CITY OF CONWAY, ARKANSAS HISTORIC DISTRICT COMMISSION

October 24, 2022 • 5:30pm • 1111 Main Street

2125 Robinson Avenue - Permanent Building Conway Regional Wound Clinic

1828 Mill Street - New Single-Family Residence

EAST ELEVATION

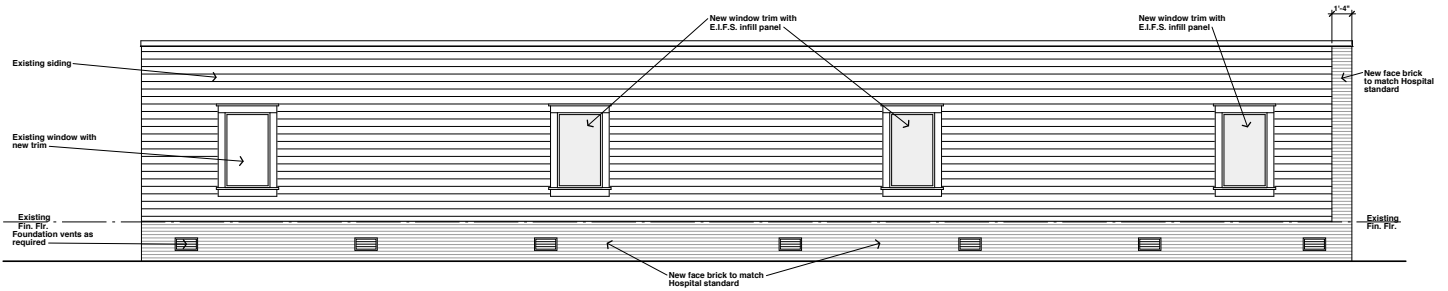
The applicant is proposing the use of brick and Hardie® siding across the structure. The applicant is proposing a brick soldier course, a canopy, and false windows to make the structure appear less like a temporary building and fit within the pattern language of structures on the Conway Regional Medical Center campus.

1. Defer review of landscaping requirements to the development review phase, except that enhanced landscaping shall be required along the front façade to mitigate the appearance of the height of the structure that gives it the appearance of a temporary building.
2. HVAC/mechanical equipment be screened in a manner to minimize its visibility from the street.
3. Site development review shall be required for the site prior to the issuance of a building permit.

1828 Mill Street - New Single-Family Residence

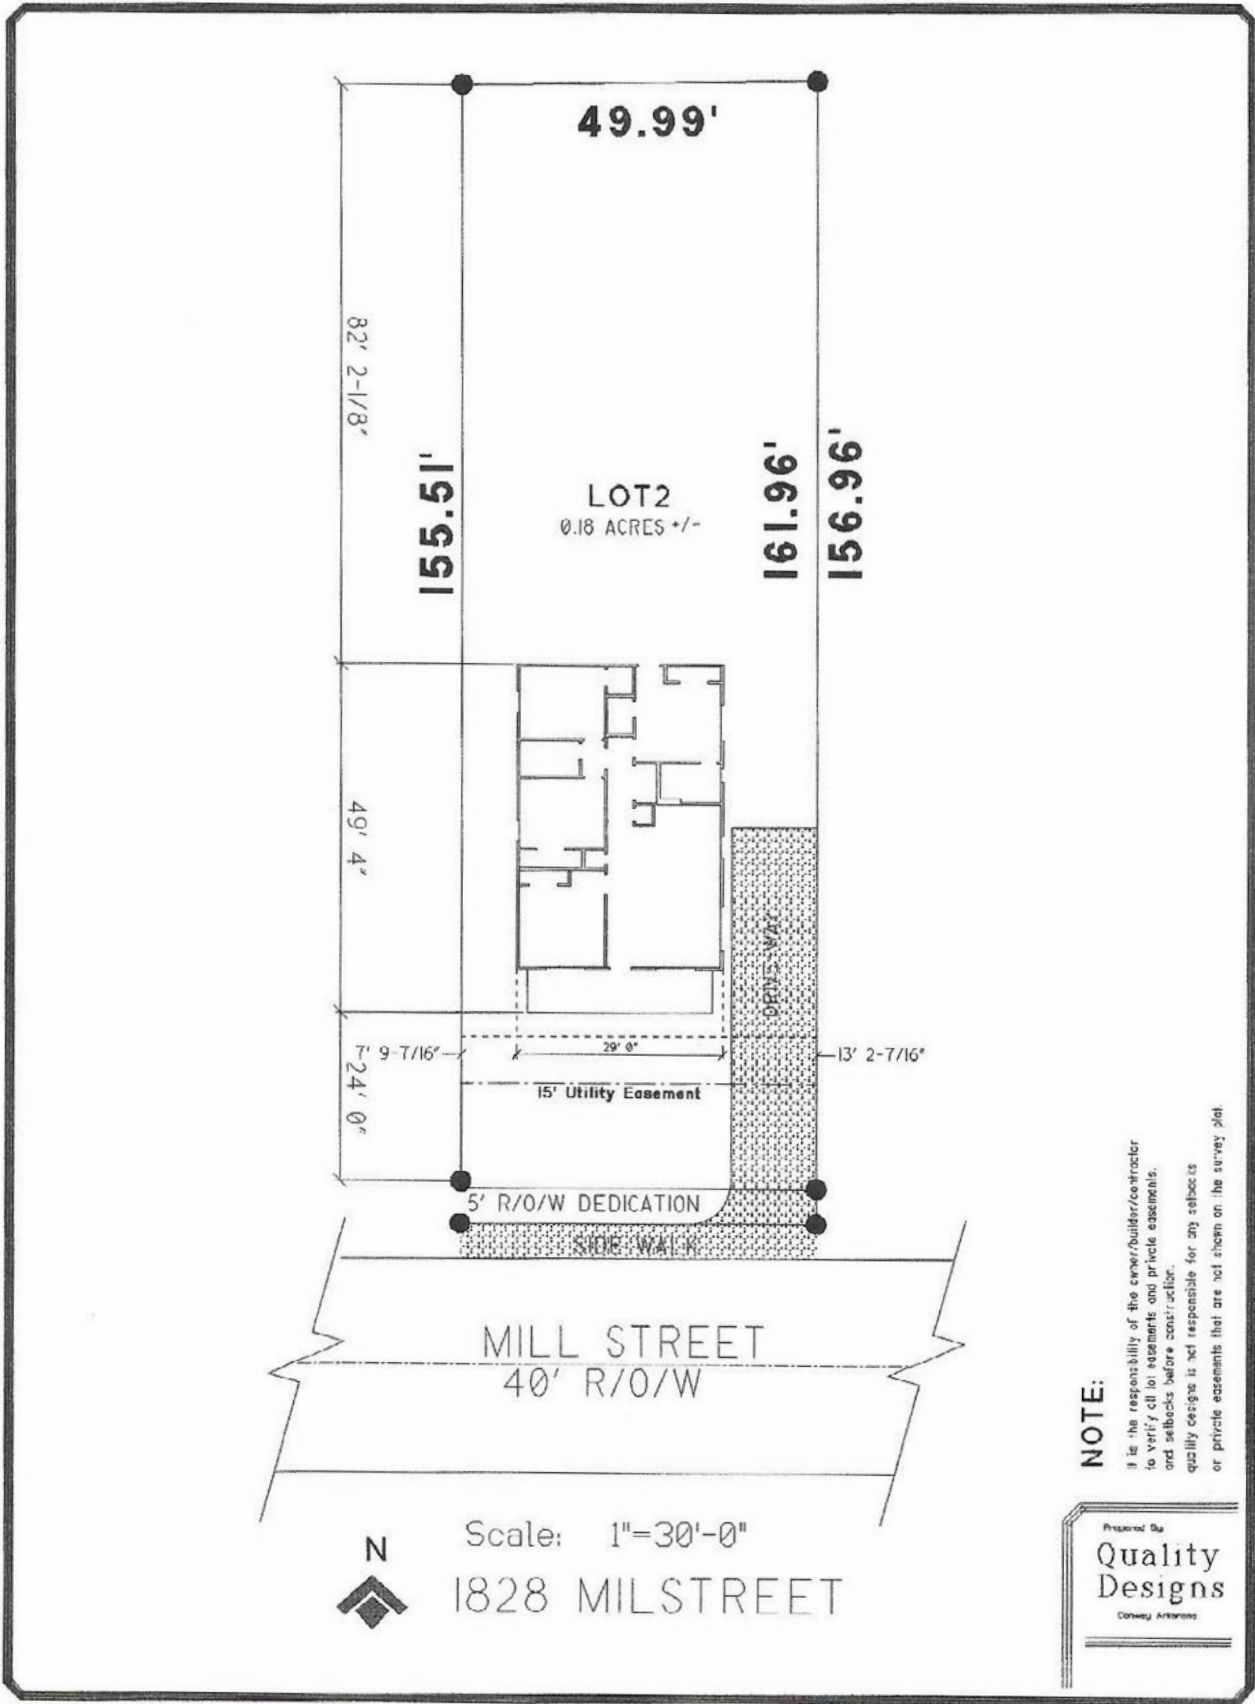
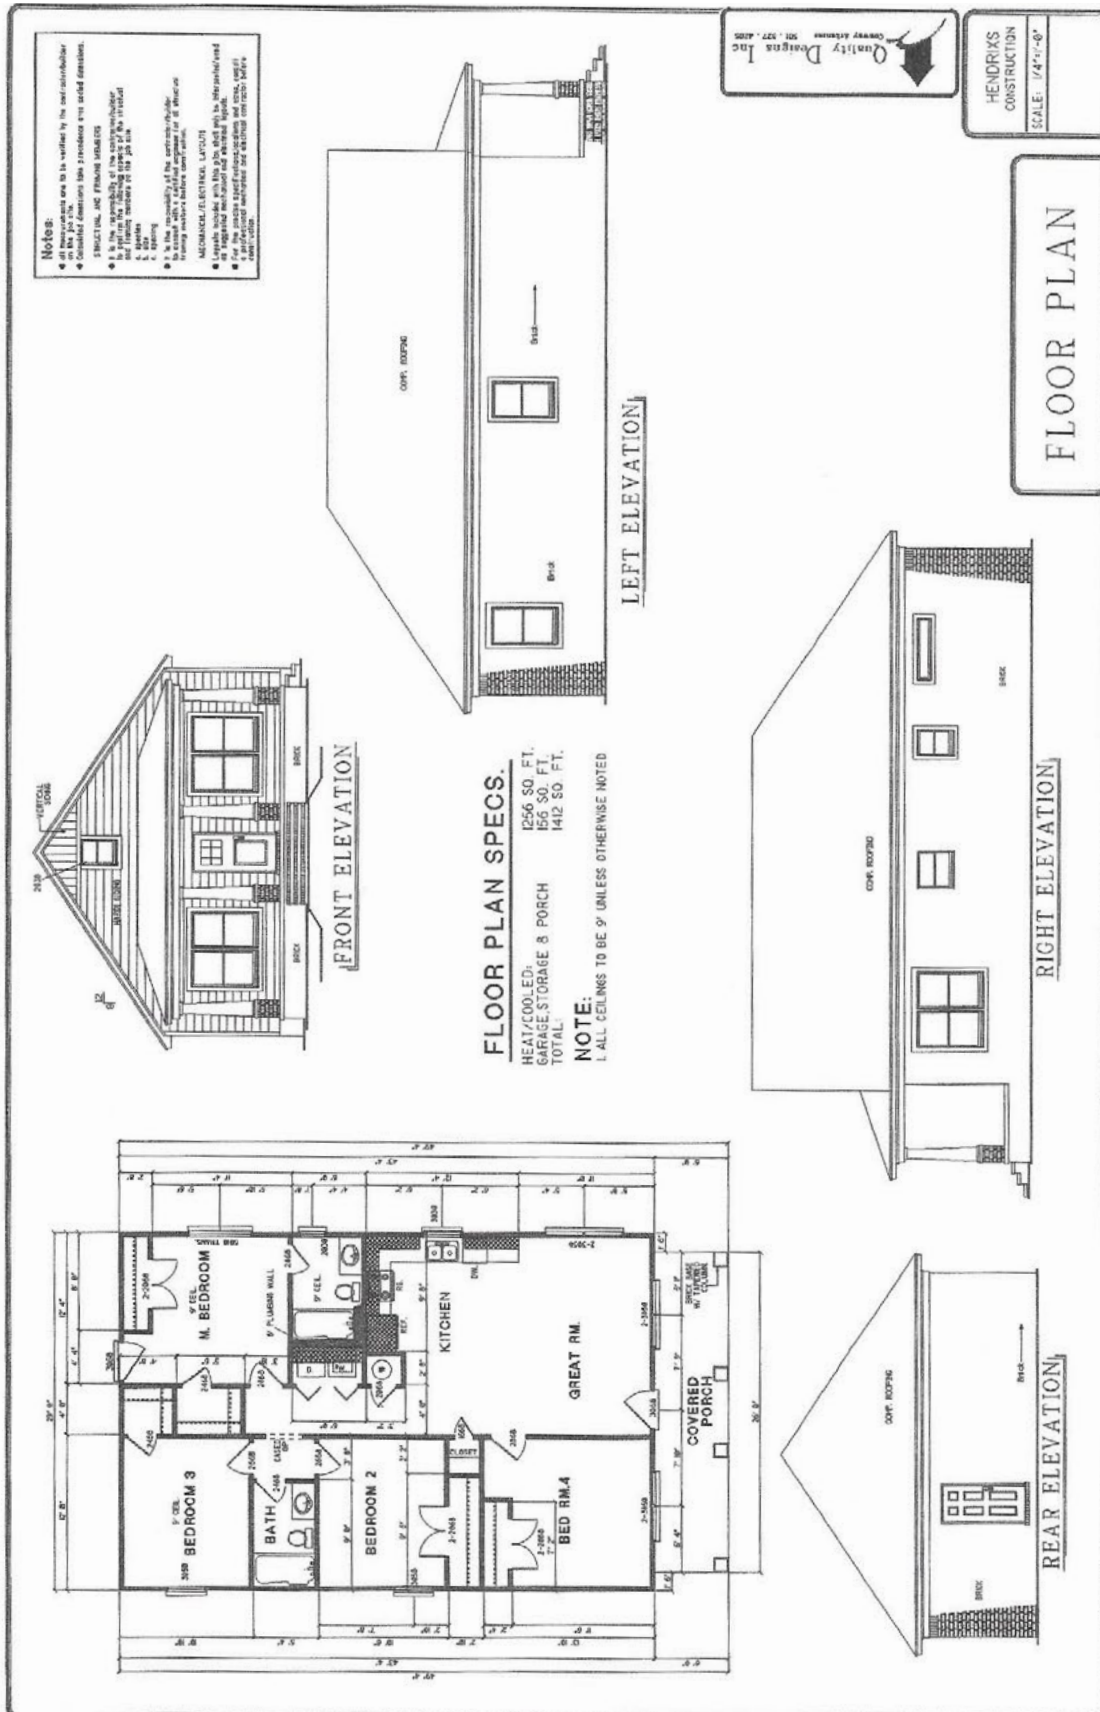
The applicant has proposed a 13' driveway with two parking spaces located at the side of the structure. Recommend requiring the driveway not exceed 12' in width and the house be sited to allow a 2' buffer from the edge of the driveway to the side lot line.

Sidewalks exist on the site. Recommend requiring a front walkway connecting the front door of the house to the street

The front façade will be composed of 24% windows and openings, which is appropriate. Recommend requiring one additional window on the west side of bedroom 4.

1. Require a front walkway to connect to the required sidewalk.
2. Planting of 1 canopy tree in the front yard is required, if the existing tree is removed.
3. Require all windows be 1-over-1 design and feature wide trim.
4. Require an additional window on the west elevation of the structure in bedroom 4.
5. Require fascia and soffits to be finished with wood or wood equivalent construction (Hardie® siding).
6. HVAC equipment be placed in a manner to minimize its visibility from the street.
7. Driveway shall not exceed 12' width and shall be placed at least 2' from the east property line.
8. ***Submit revised drawings to the Planning Director for approval prior to release of the COA.***
